TITLE SHEET	1
SHEET INDEX, ENGINEERS SEALS & CITY OF COLUMBUS SIGNATURES	2
PLAN LEGEND & DESIGN DESIGNATIONS	3
SCHEMATIC PLAN	4 - 7
GEOMETRIC PLAN	8 - 12
CURVE DATA	13 - 16
REFERENCE POINTS AND BENCHMARKS	17
CONTROL POINT KEY MAP	18
INTERSECTION DATA TABLE	19
TYPICAL SECTIONS	20 - 52
GENERAL NOTES	53 - 69, 66A, 67A, 68A, 69A, 69B
SUMMARY OF 4R PART 1 / 6R PART 2	
MOT SEQUENCING	69C
MAINTENANCE OF TRAFFIC	70 - 210, 71A, 71B, 78A, 81A, 102A, 159A-159C, 189A - 189P
GENERAL SUMMARY	211 - 218
SUBSUMMARIES	219 - 229, 225A
ESTIMATED QUANTITIES	230 - 255, 252A, 252B
CALCULATIONS	256 - 260
PROJECT SITE PLAN	261 - 264
PLAN AND PROFILE - I-70 EB	265 - 303
PLAN AND PROFILE - I-71 NB	304 - 315
PLAN AND PROFILE - RAMP A5	316 - 323
PLAN AND PROFILE - FUTURE RAMP B5	324
PLAN AND PROFILE - RAMP C3	325 - 330
PLAN AND PROFILE - RAMP C5	331 - 361
PLAN AND PROFILE - RAMP C6	362 - 367
PLAN AND PROFILE - FRONT STREET	368 - 369
PLAN AND PROFILE - FULTON STREET	370 - 371

NO.	DESCRIPTION	REV. BY	DATE
1	UPDATED SHEETS	CWL	11-5-2021
2	UPDATED SHEETS	CWL	11-12-2021

CALCULATED ATR CHECKED CWL
SHEET INDEX, ENGINEERS SEALS & COLUMBUS SIGNATURES
FRA-70/71-12.68/14.86
2
1815

FRAMING PLAN
FRA-70-1282R
RAMP C5 OVER SOUDER AVE.

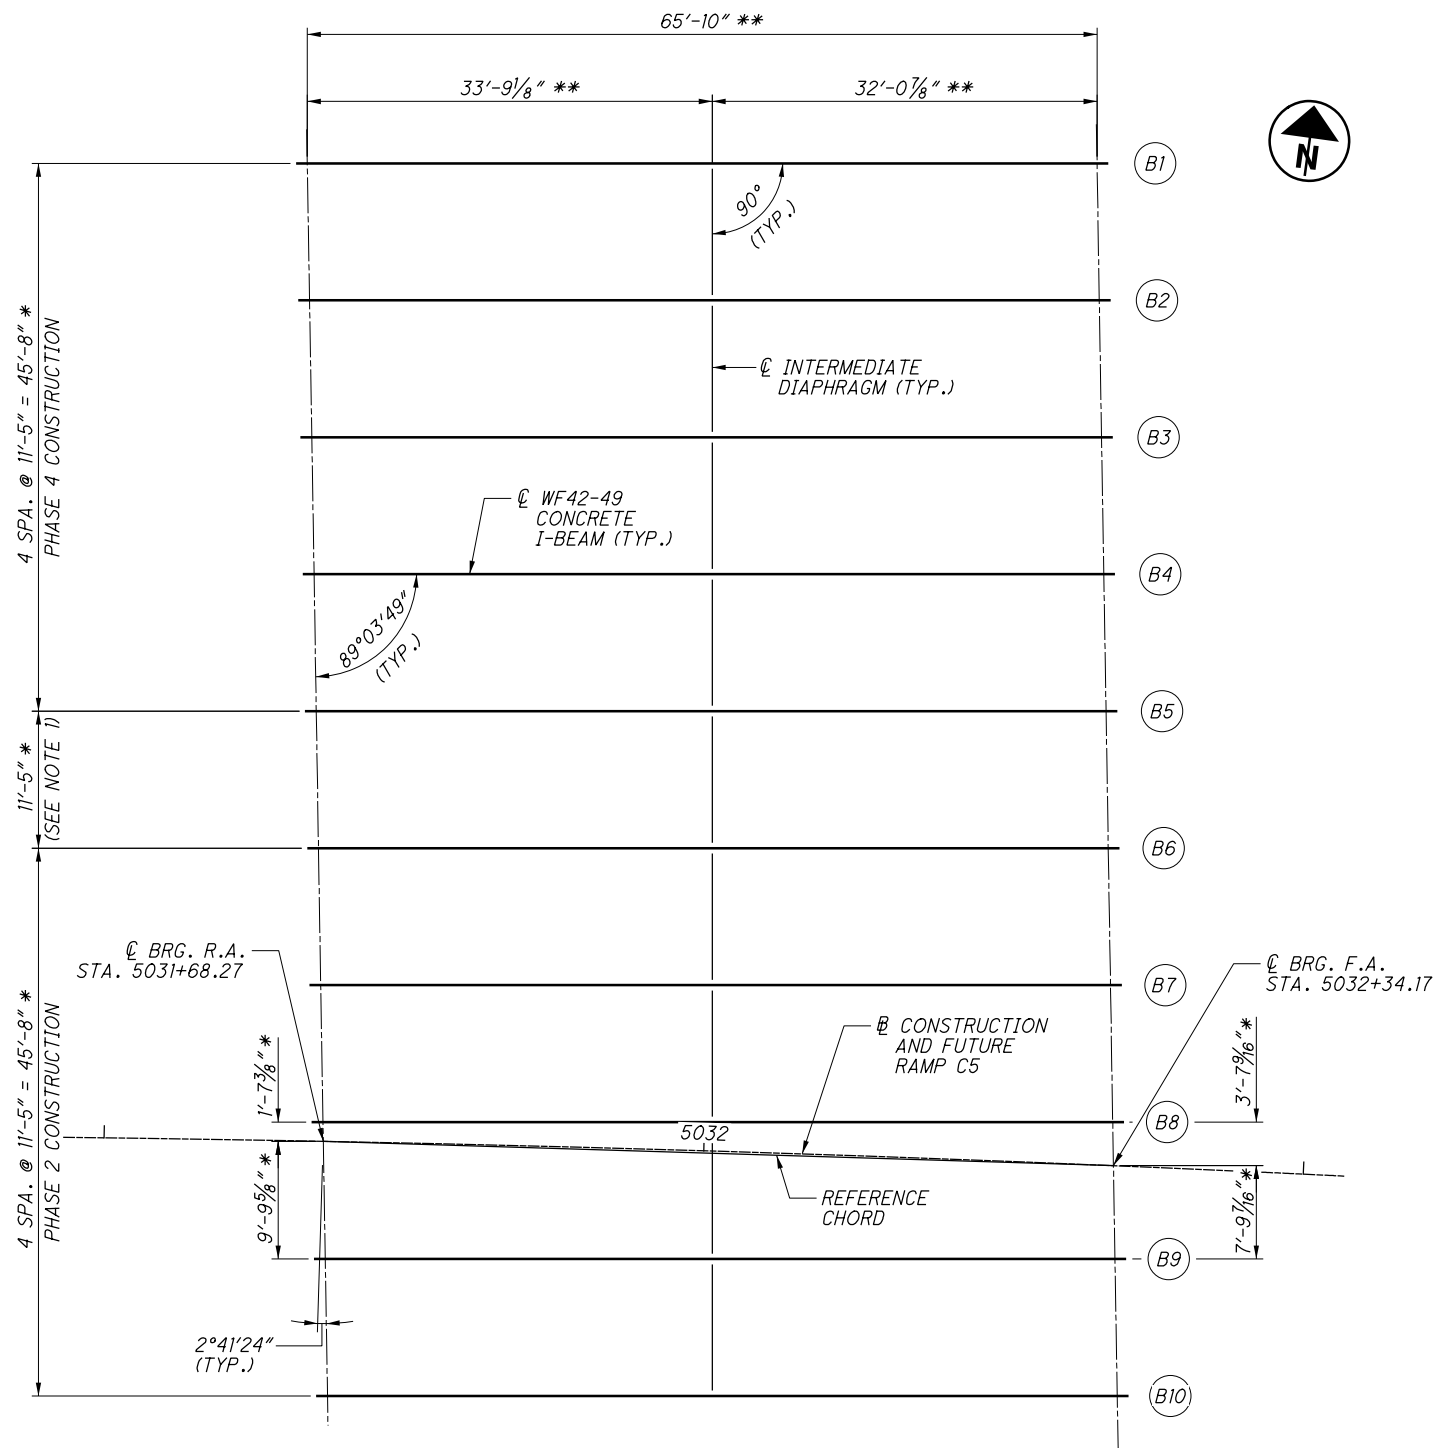
NUMBER	DESCRIPTION	REVISED BY	DATE
2	ADDED NOTE 5	CAS	11-8-2021

APPROACH SLAB PLAN
 BRIDGE NO. FRA-70-1395C
 S. FRONT STREET OVER I-70/71

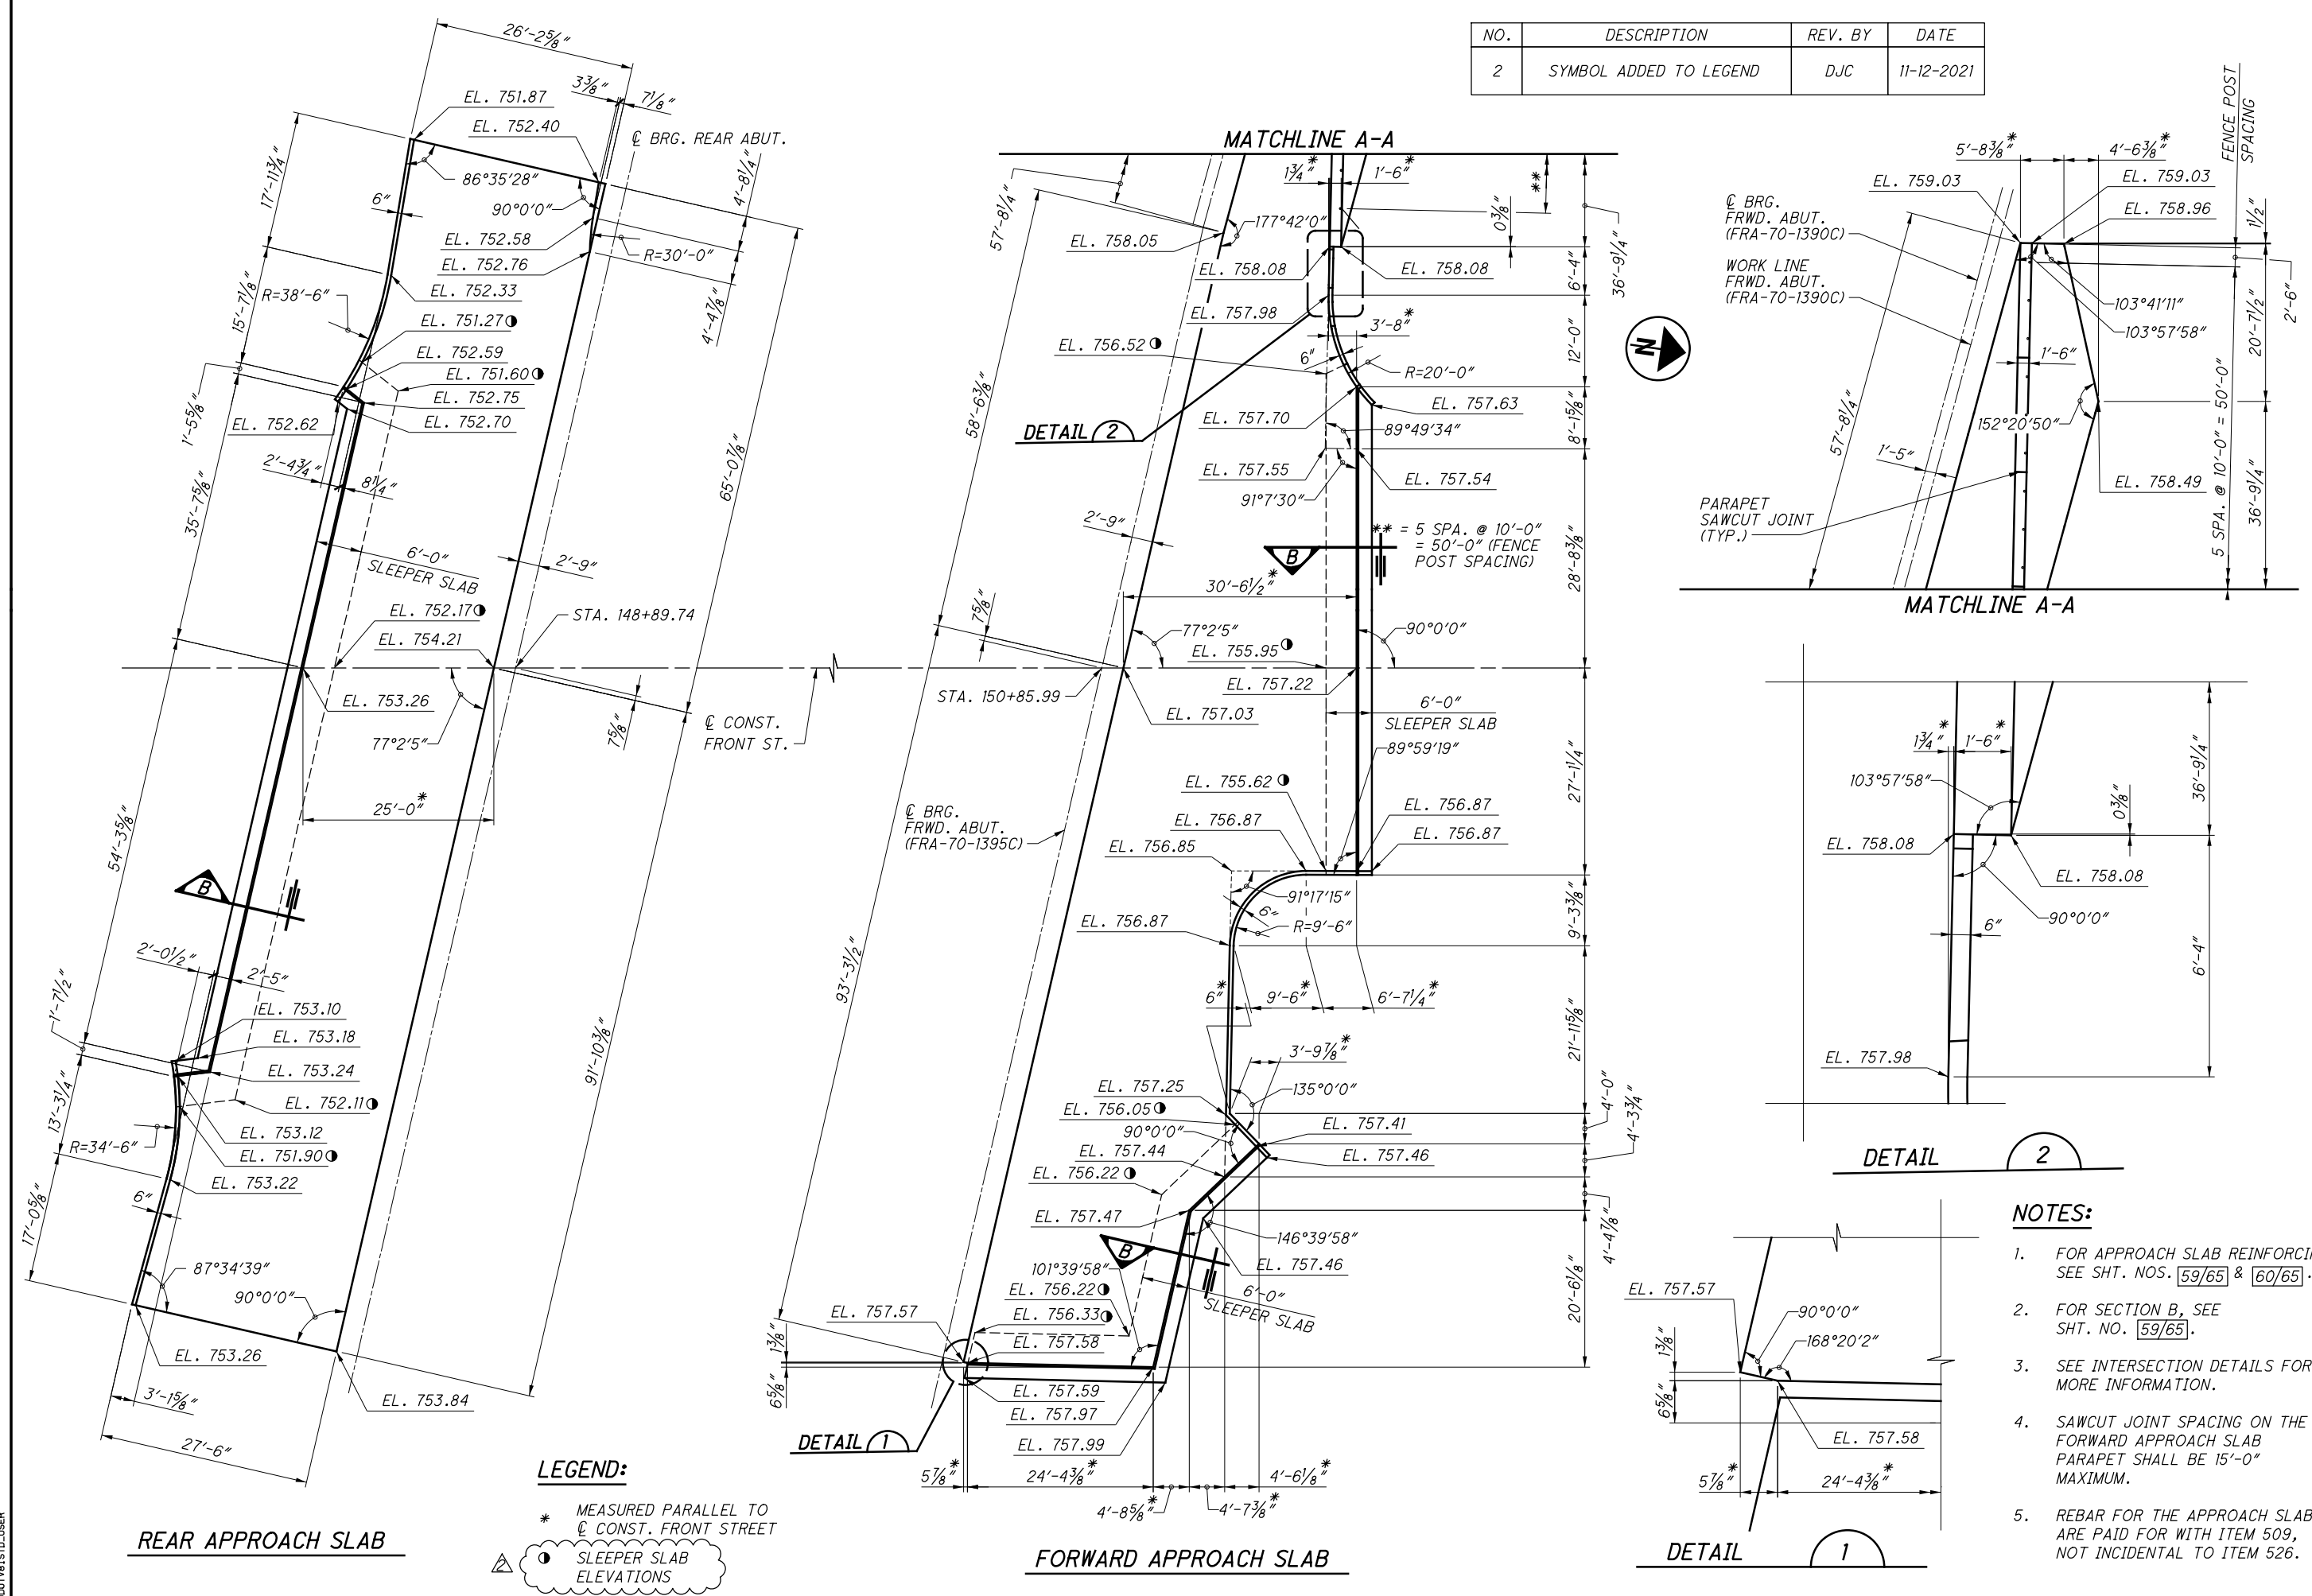
NO.	DESCRIPTION	REV. BY	DATE
2	SYMBOL ADDED TO LEGEND	DJC	11-12-2021

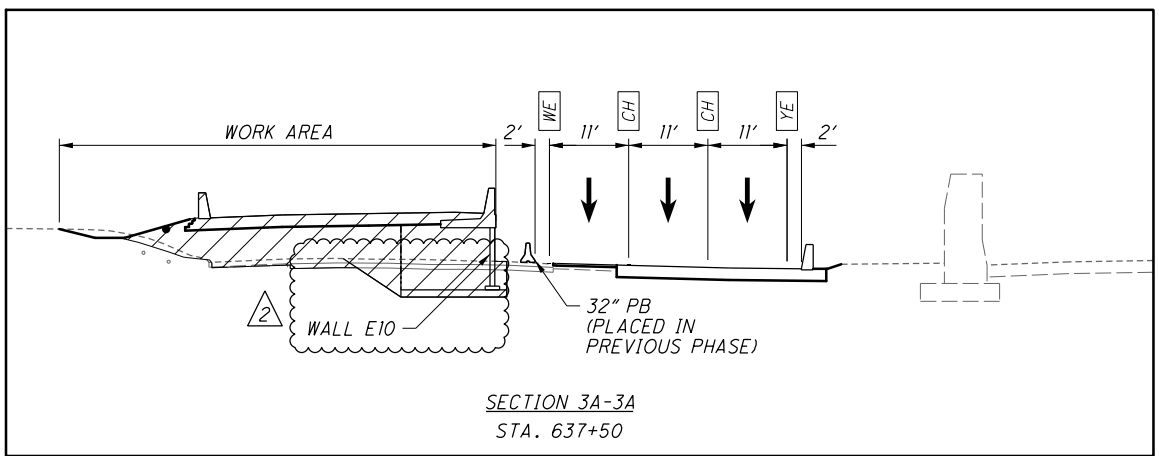
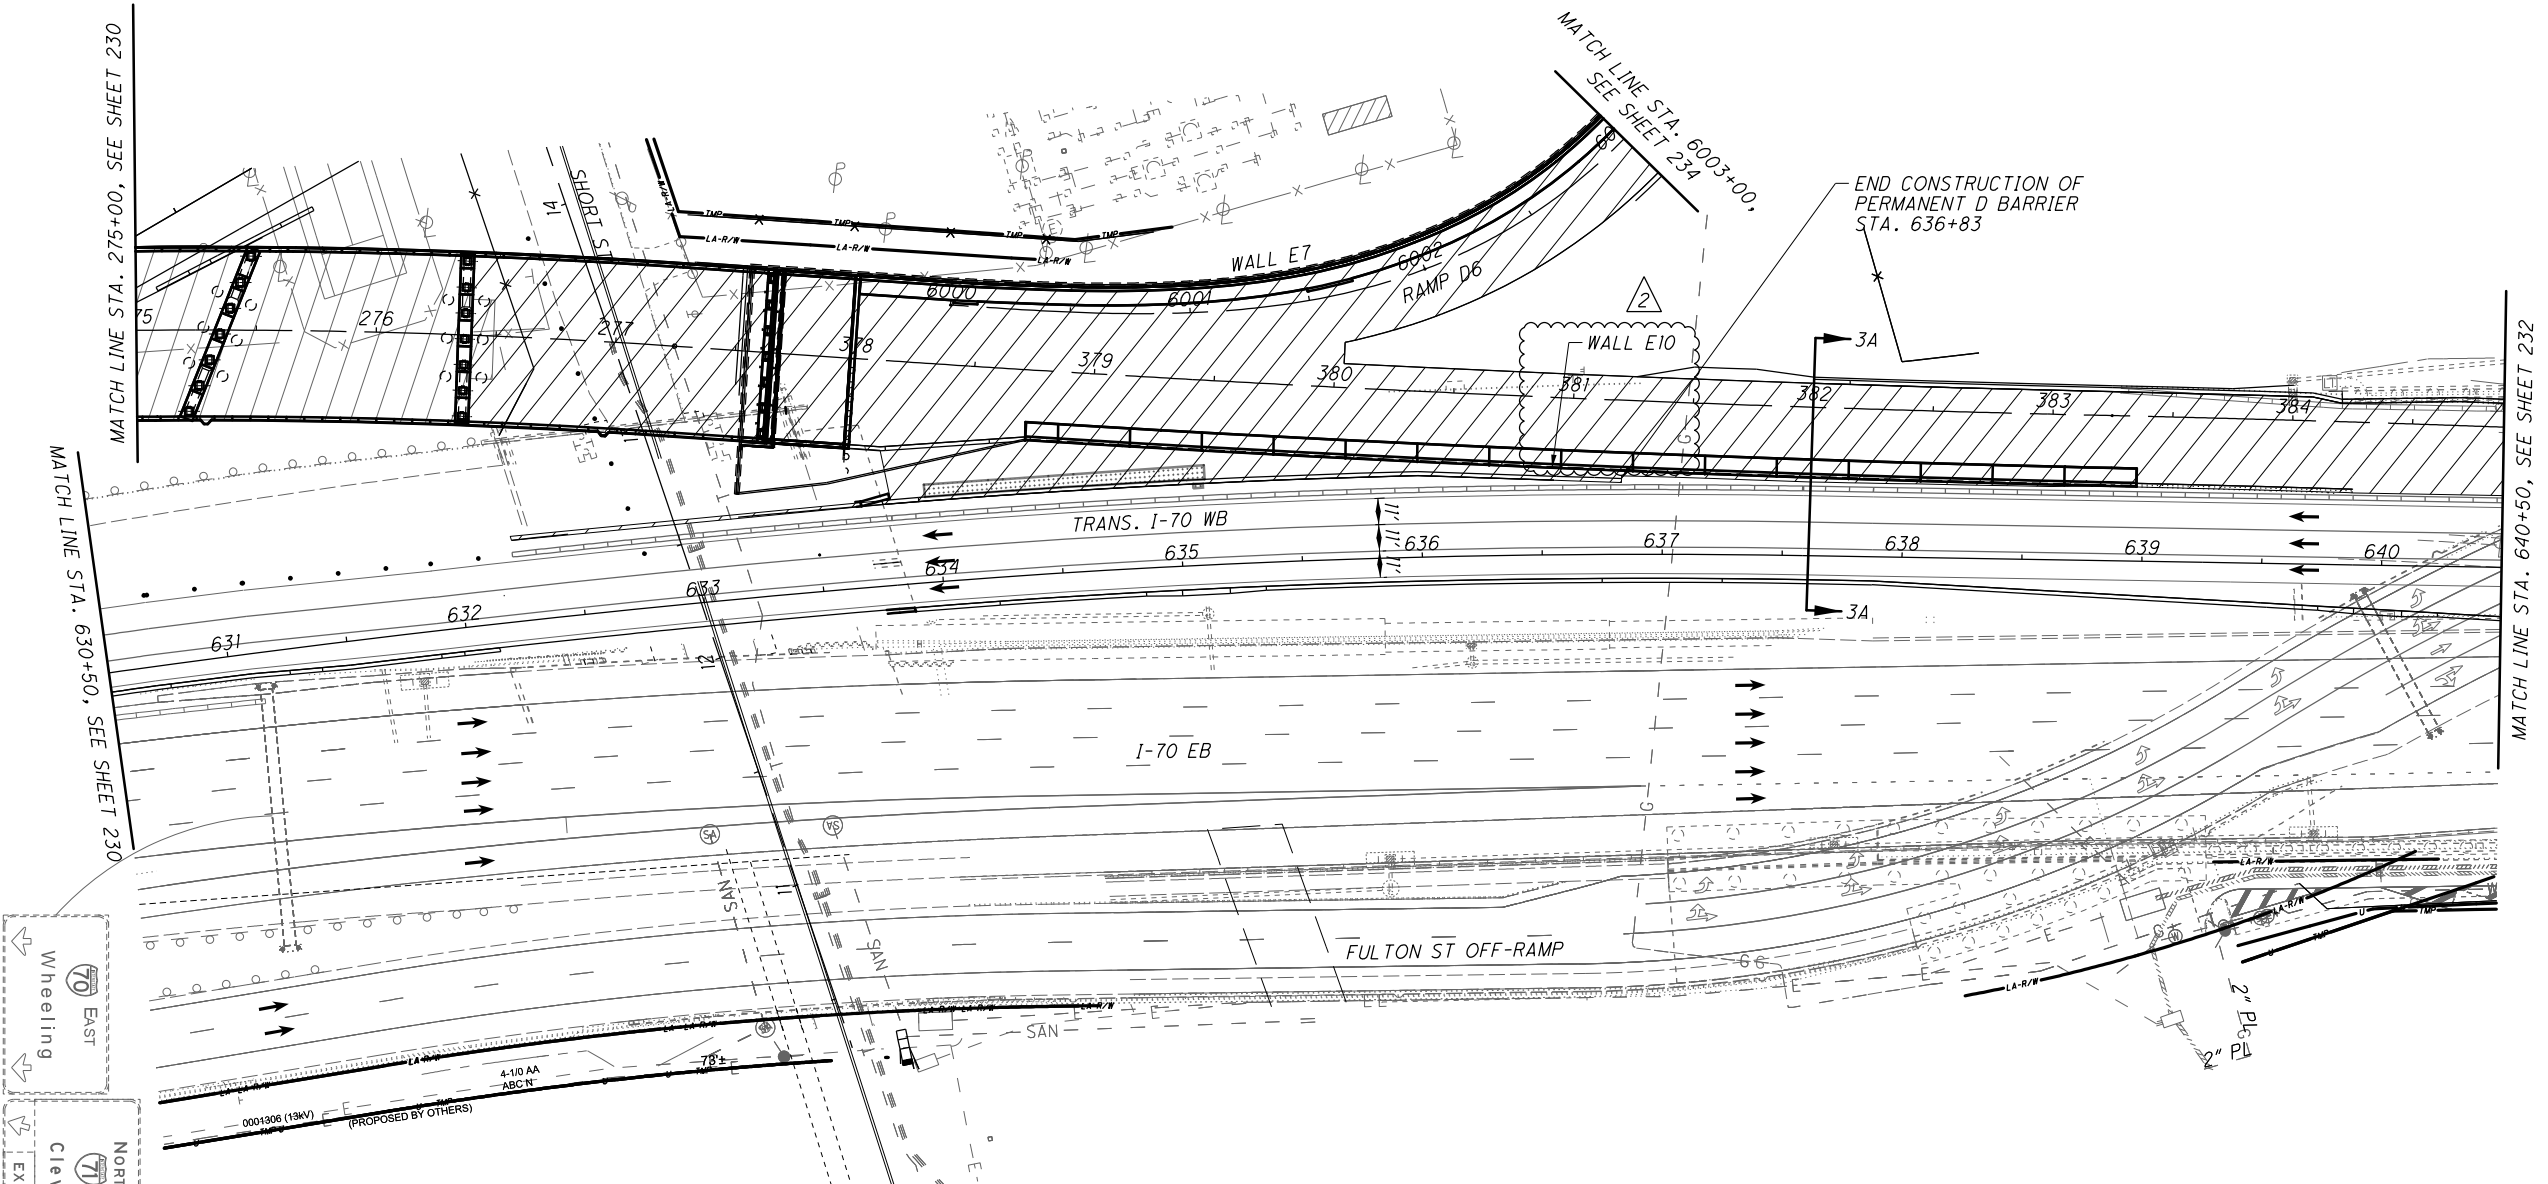
NO.	DESCRIPTION	REV. BY	DATE
2	ADDED WALLS E7 & E10	KWR	11-08-2021

NO.	DESCRIPTION	REV. BY	DATE
2	ADDED LABEL FOR WALL E10	KWR	11-08-2021
